## REQUEST

Current Zoning: RE-1 (research district)  
Proposed Zoning: UR-2(CD) (urban residential, conditional)

The petition proposes development of a vacant site in the University Research Park area for up to 82 single-family attached townhomes.

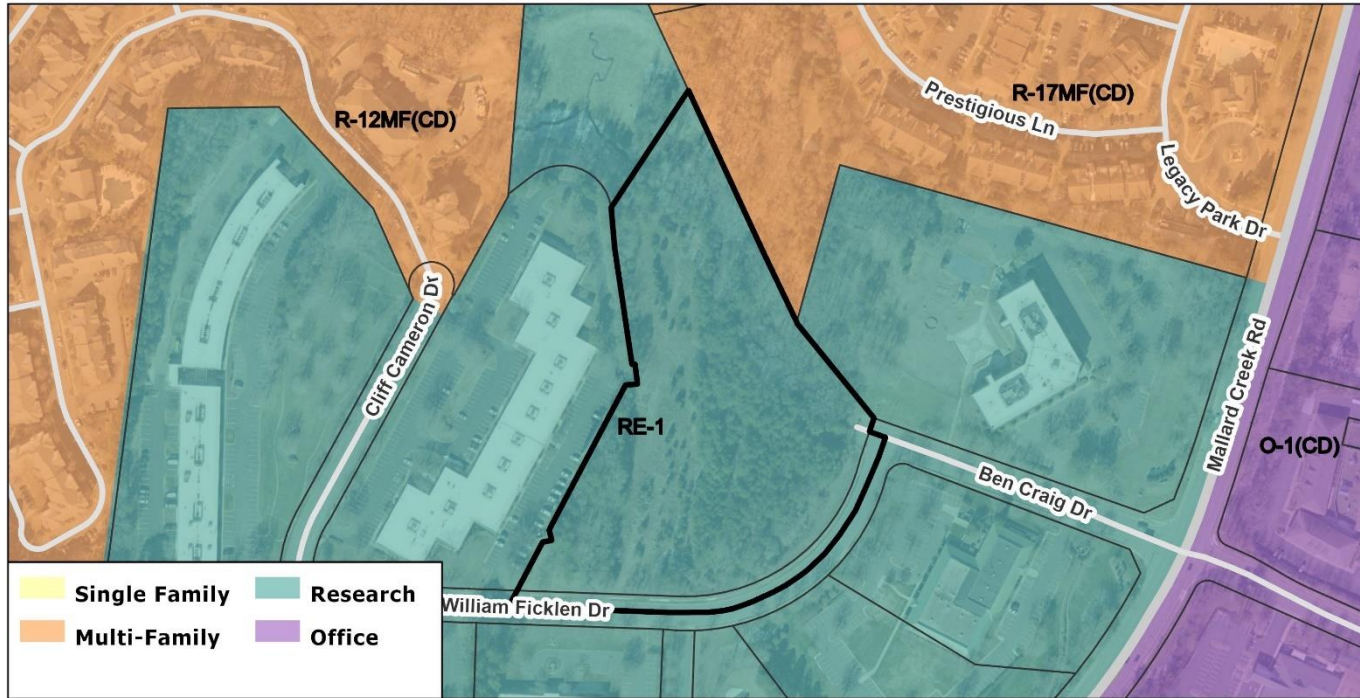
1. ~~Add a conditional note specifying "A Right of Way Encroachment Agreement is required for the installation of any non-standard item(s) (irrigation systems, decorative concrete pavement, brick pavers, etc.) within a proposed/existing City-maintained street right-of-way by a private individual, group, business, or homeowner's/business association. An encroachment agreement must be approved by CDOT prior to construction/installation. Contact CDOT for additional information concerning cost, submittal, and liability insurance coverage requirements."~~ Addressed

2. ~~Revise conditional notes to commit to meeting all Intersection sight distance requirements along William Ficklen Drive frontage. If ISD cannot be met changes to site access will be required.~~ Addressed

3. ~~Revise conditional note(s) to commit to meeting intersection sight distance requirements. Site entrance locations will be required to meet all ISD requirements.~~ Addressed

4. ~~Revise site plan to show proper separation between the proposed on-street parking and the intersection. A minimum of 20 feet is required from the curb return to the parking stall.~~ Addressed

5. ~~Add a conditional note specifying "All transportation improvements will be approved and constructed before the site's first building certificate of occupancy is issued. The petitioner may phase transportation improvements if said improvements and phasing are explicitly described in site plan notes."~~ Addressed

6. ~~Provide an 8-foot sidewalk and an 8-foot planting strip along frontage of William Ficklen Drive.~~ Addressed
